**Alabama State Port Authority**  
***Addendum to R&P or Specification Booklet***

**Project Name: Pier B South Replacement**

**ADDENDUM No. 2**

Title  
PIER B SOUTH REPLACEMENT  
PIER & RELIEVING PLATFORM  
SUBSTRUCTURE PLANS  
AREAS 2 & 3

Designed	MJT	Eng Check	JQ
Drawn	KWD	Coordination	LJD
Dwg Check	MJT/JPE	Approved	LJD
Scale at ANSI D As Shown	Status IFB	Rev D	Security STD
Drawing Number	MA-04

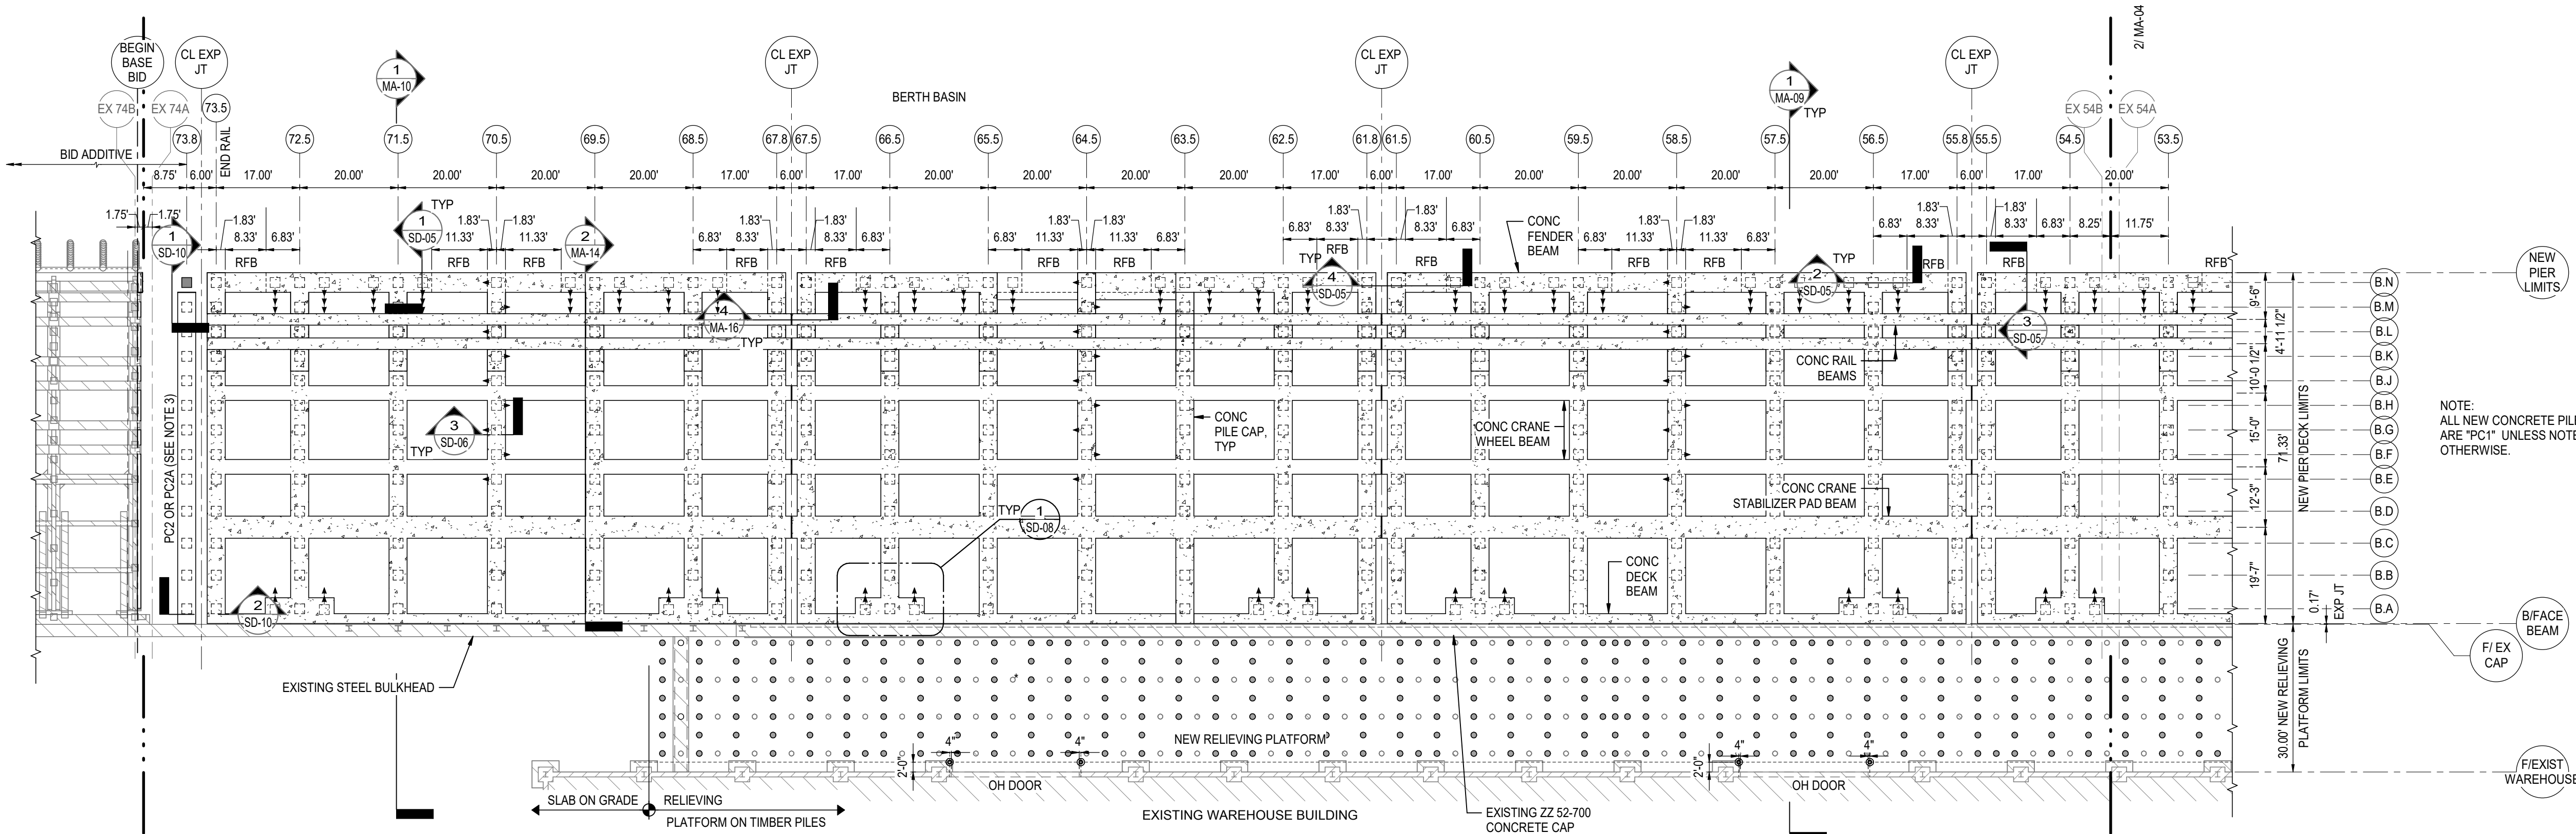
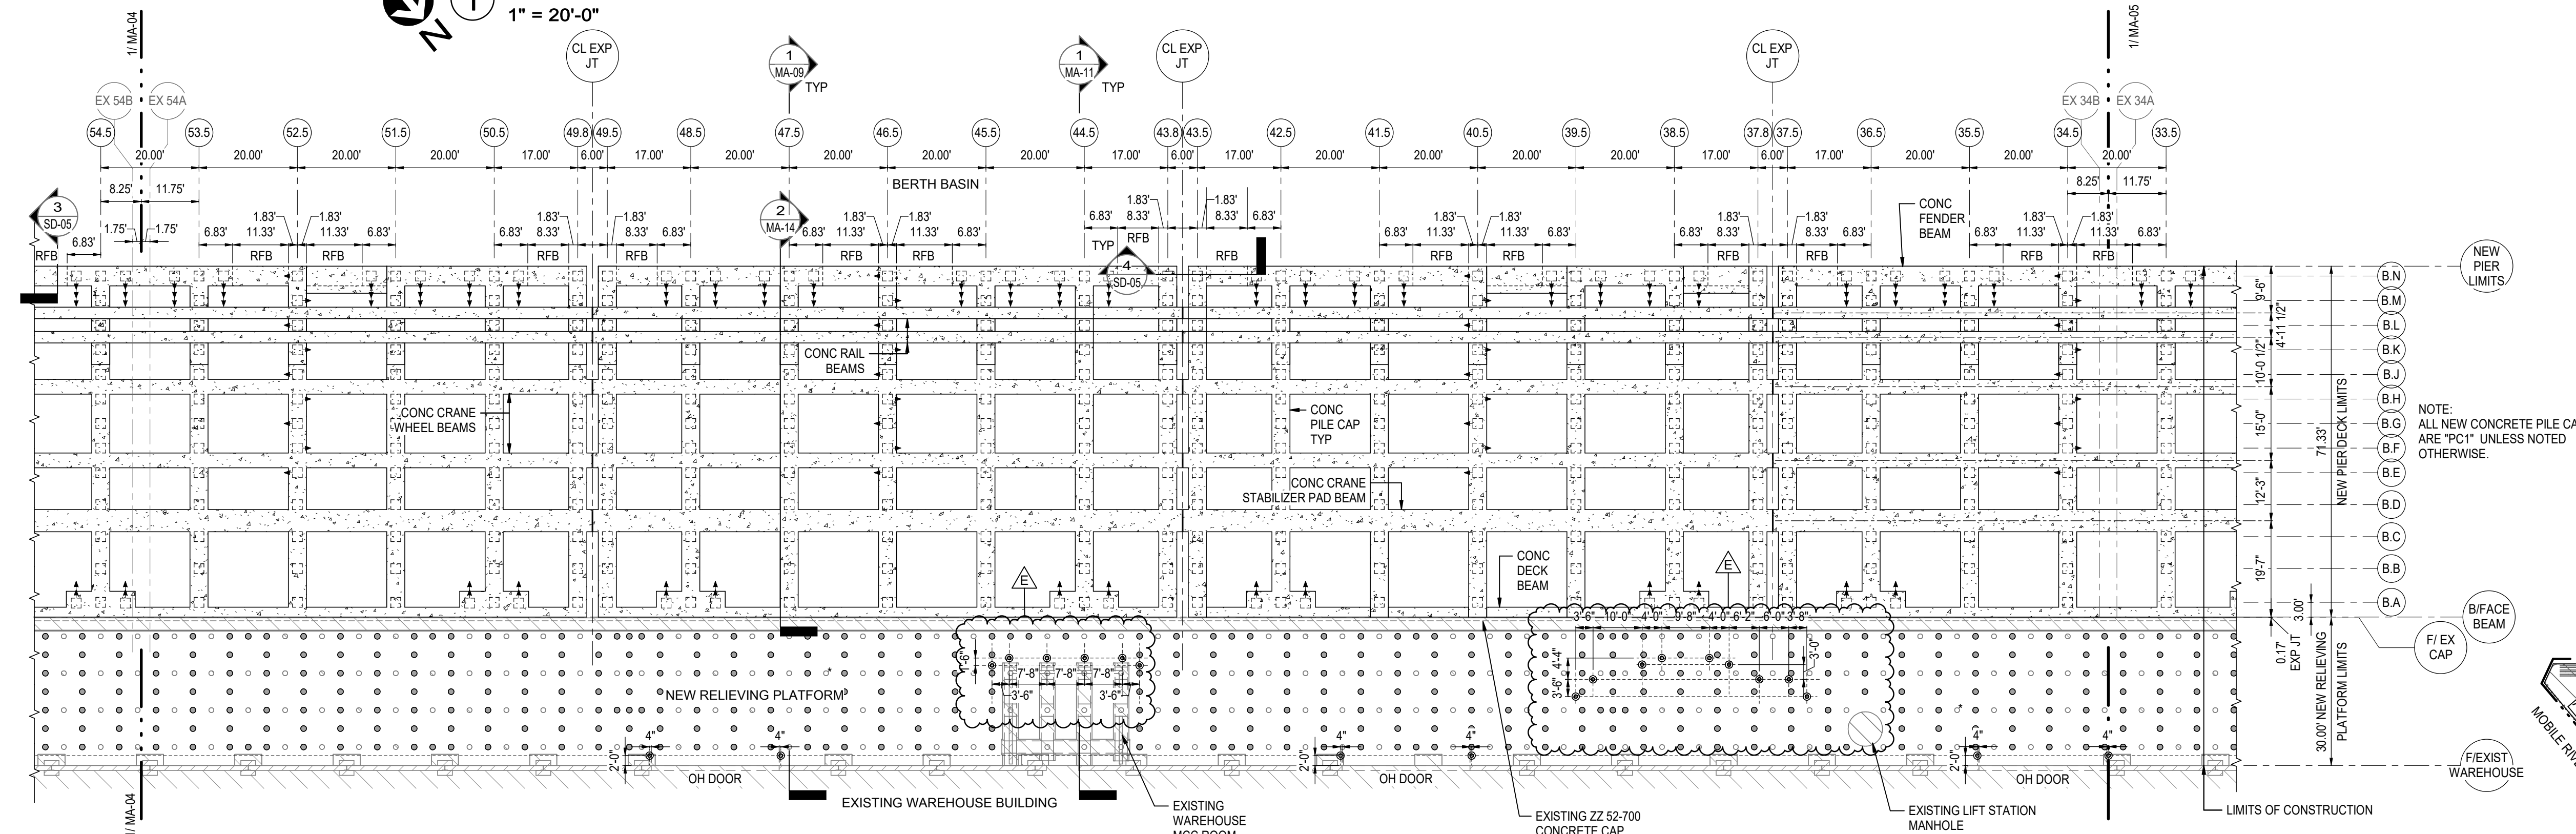
5. MA-04, Refer to Revision E on attached drawing.
6. MA-03, Revise existing Bent 1 sheet pile note as follows –

29. In between pile bent lines 37.8 and 38.5 there is an auger cast pile in the belly of the sheets. Please advise if this is intentional, or is it necessary to core through the existing pile cap and drill an auger cast pile.

*Response: No. Refer to Reference Drawings, Item 5.*
